EXHIBIT A

Supplemental Appeal Letter)

MONTECITO PLANNING COMMISSION

Coastal Zone Staff Report for Music Academy of the West CUP Revision

Figure 8: CNEL Noise Contours for 3-Hour Event at Kinnear Fountain with Source Power Level of 105 dBA

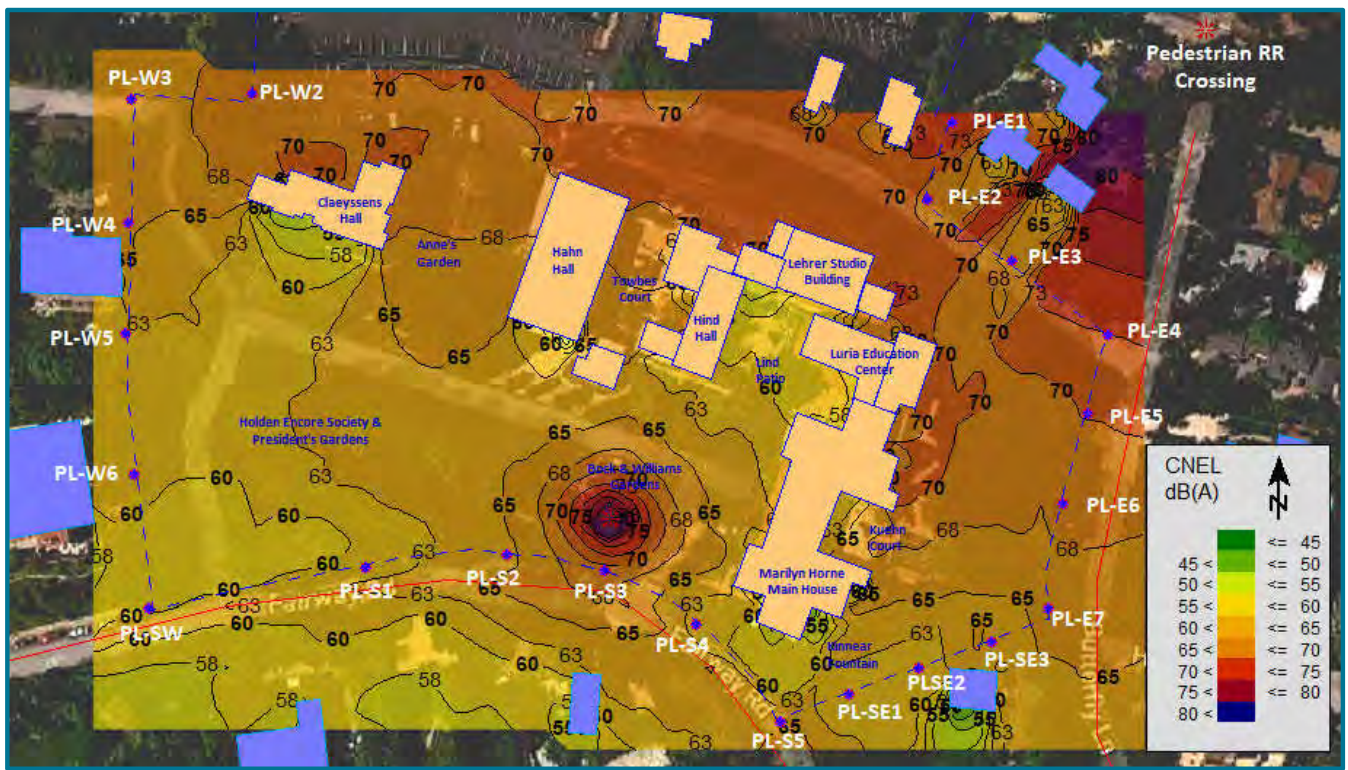
We note that the Kinnear Fountain location from our report was erroneously identified in Zone 11, when it is actually located in “Zone 5”; we have omitted “Zone 11” in our review evaluation of mitigations in this Addendum. The correct Zones are shown on the Miraflores Campus map in Figure 1.

The resulting CNEL contours for a 3-hour event with the source in Zone 11 (Kinneer Fountain) having a sound power level of 105 dBA are shown below in Figure 8. Similar to events held in the Bock & Williams Gardens, events in this location are also predicted to exceed the 65 dBA CNEL limits at the southeast property line.
